Re: Addendum To Drainage Report For The Tuscany West Subdivision, Units I & II
(Reference File A11/D1A)

TUSCANY WEST SUBDIVISION UNITS 1 and 2 AMENDED DRAINAGE AREA BASIN MAP

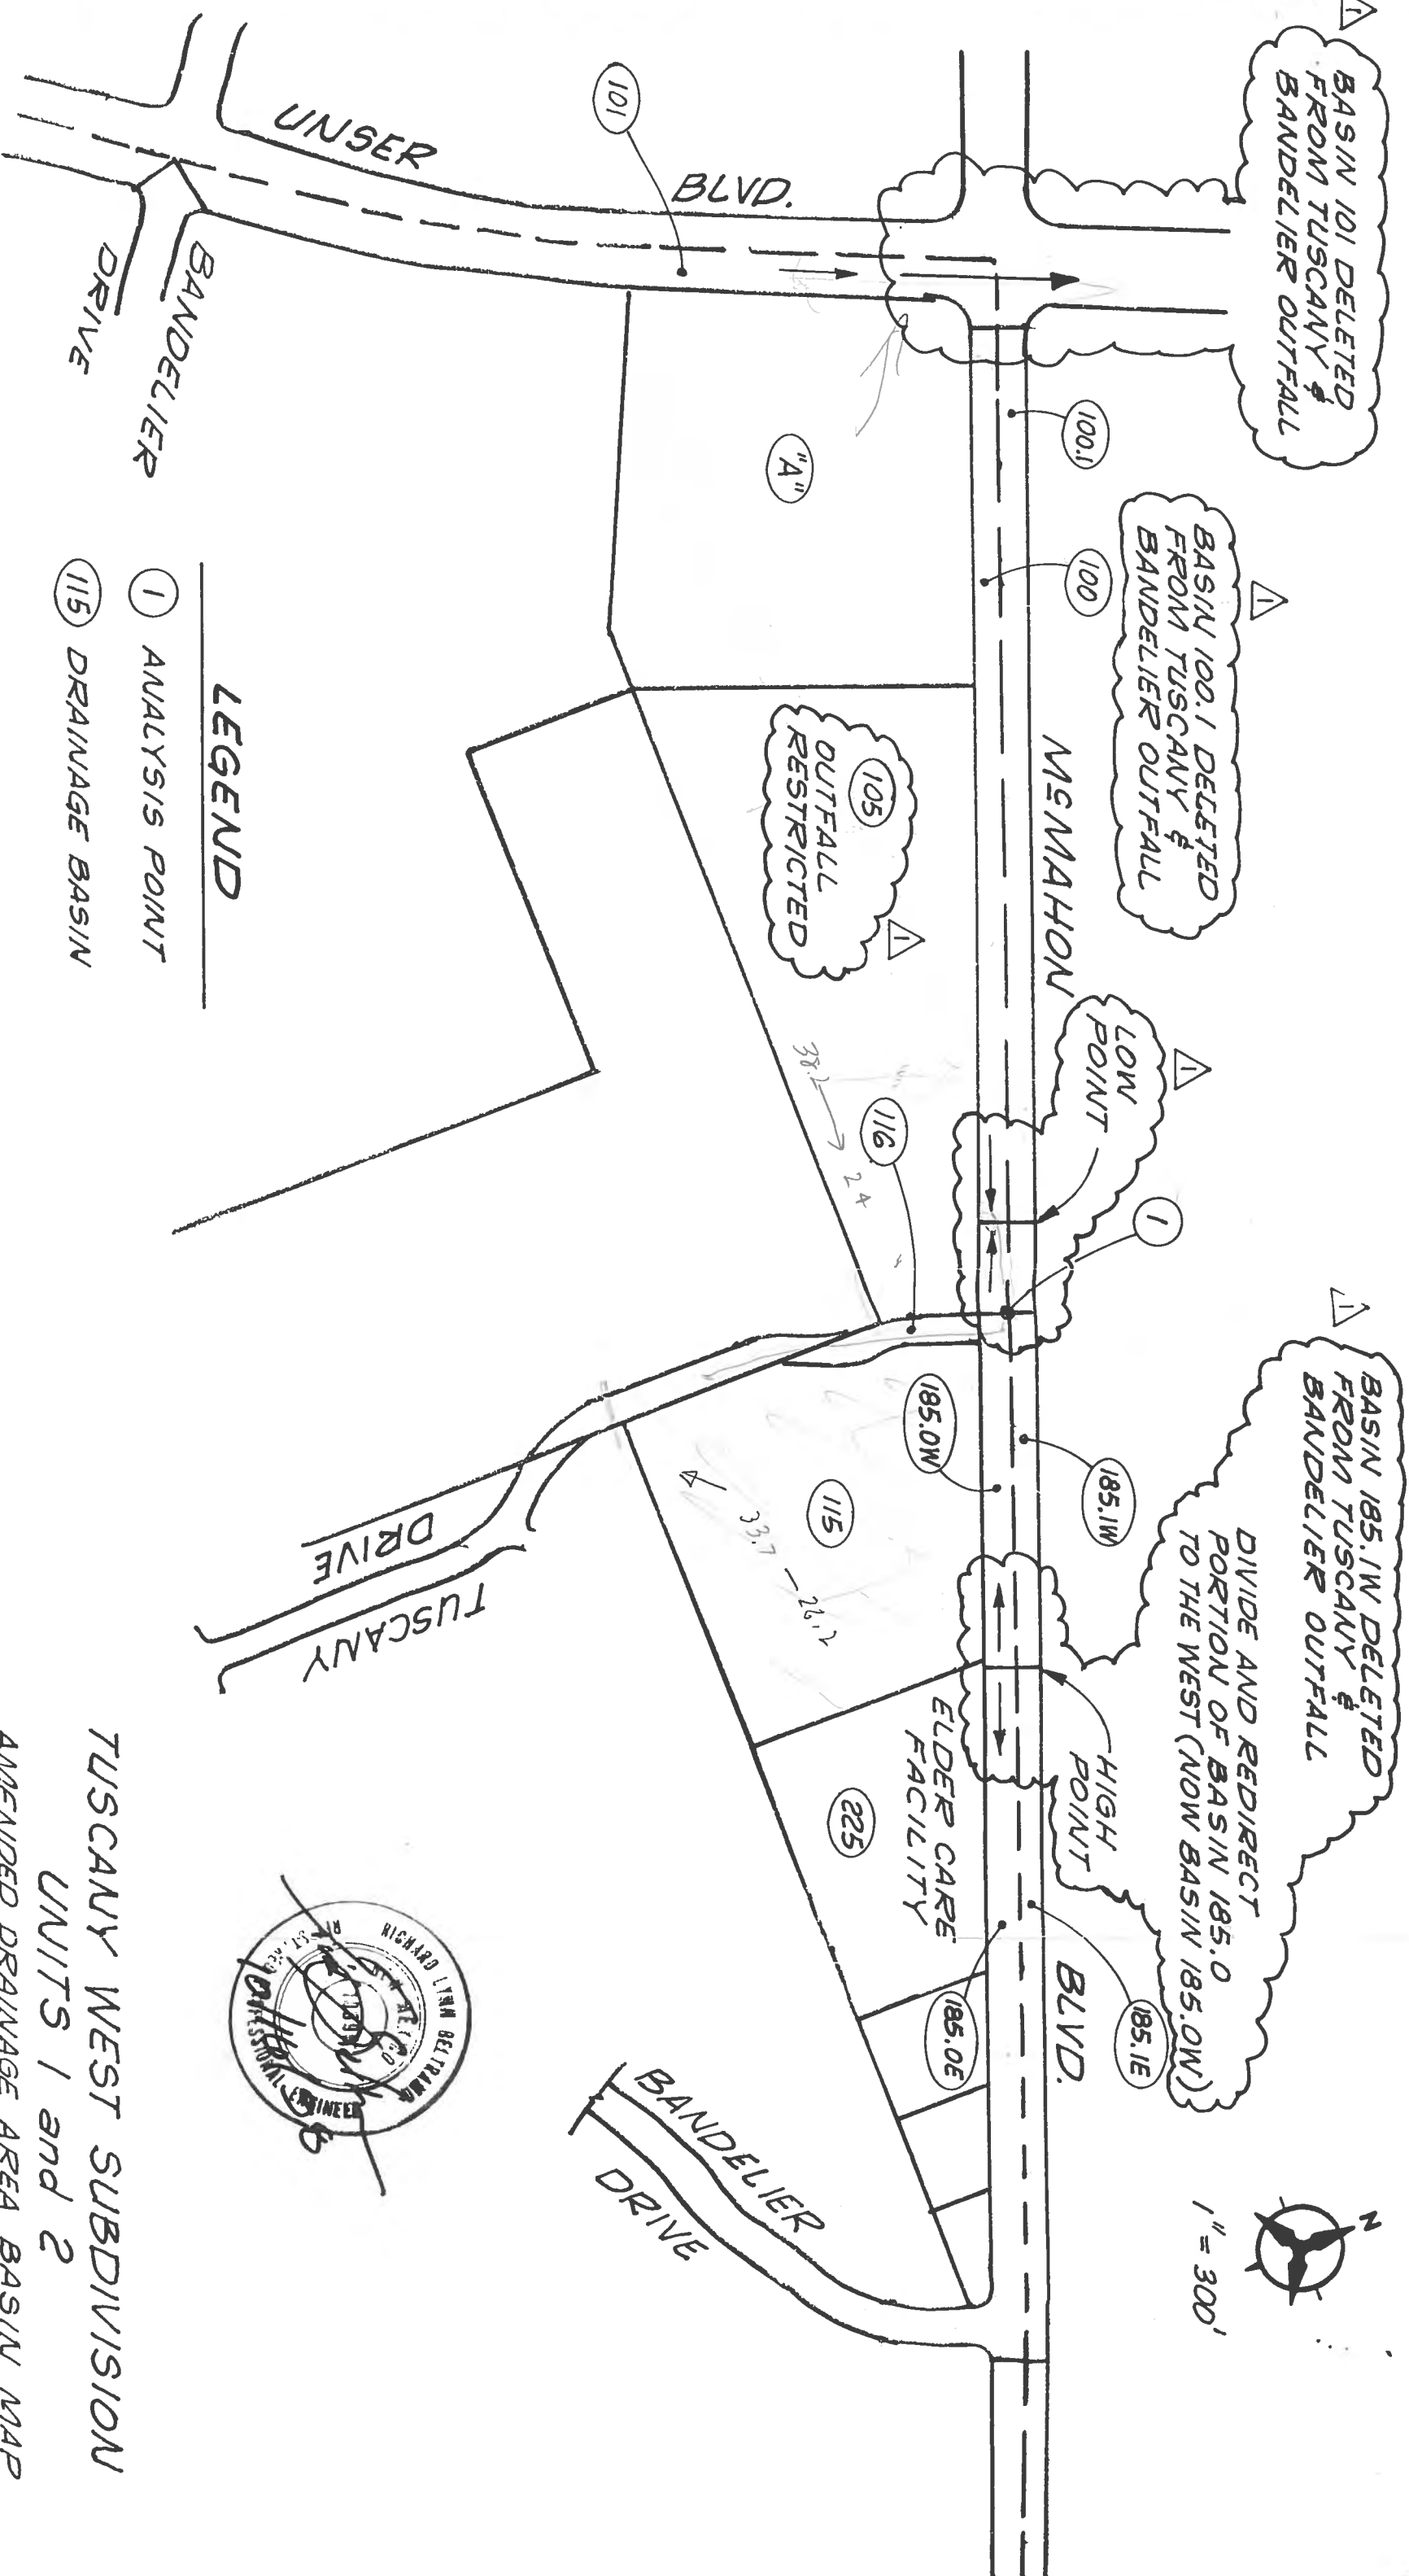
The issue addressed by this addendum is the ultimate design profile of McMahon Blvd. As an alternative, this report proposes to create a low point in McMahon just west of the intersection with Tuscany Drive (see exhibit attached). By placing the vertical grade low point at this location, approximately 40 cfs must be conveyed to an acceptable outfall or must be intercepted before reaching the low point. 40 cfs is the flow rate in excess of the capacity of the Tuscany Drive storm drain.

- 4) The revised design concept for McMahon Blvd., per this study, shall consists of a low point in McMahon Blvd. approximately 200 ft. west of Tuscany Drive. McMahon Blvd. will connect to Unser Blvd. with a water block east of the intersection, then continue east at a minimum grade of 0.5% to the low point. From the low point, McMahon will slope up to the east and the existing pavement grades at the Elderly Care facility. Design grades, typical sections and vertical design parameters will meet City DPM criteria for arterial pavement.

- 5) Due to the low point in McMahon Blvd. and the accompanying high point, Basins 185.1 and 185.0 are now bisected resulting in 4 basins. The four basins are 185.1e (east), 185.1w (west) 185.0e, and 185.0w. Basins 185.1w and 185.0w both drain west to the low point sump. Basins 185.1e and 185.0e continue to drain east per the DMP. Note, basin 185.1w also is removed from the Tuscany West study.

AMENDED OCT. 15, 1998
LOW POINT ADDED TO
McMAHON PROFILE
CONTRIBUTING BASINS
DELETED.
